Subject ► Changes on Ball Bearing

For Models ► HK1800, HK1800L, HK1810, HK1801L (Power Scraper)

► Current	► New
	Ball Bearing 6002LLB (Seal Color: Black)	Ball Bearing 6002LLU (Seal Color: Red.)

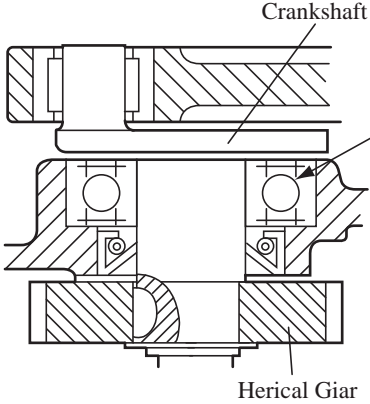
Description ► As illustrated below, Ball Bearing 6002LLB has been changed to Ball Bearing 6002LLU for improvement in endurance.

Item No.	Current part		Q'ty	I/C	New part		Q'ty	Note
16	Ball Bearing 6002LLB 211201-7		1	Yes	Ball Bearing 6002LLU 211232-6		1
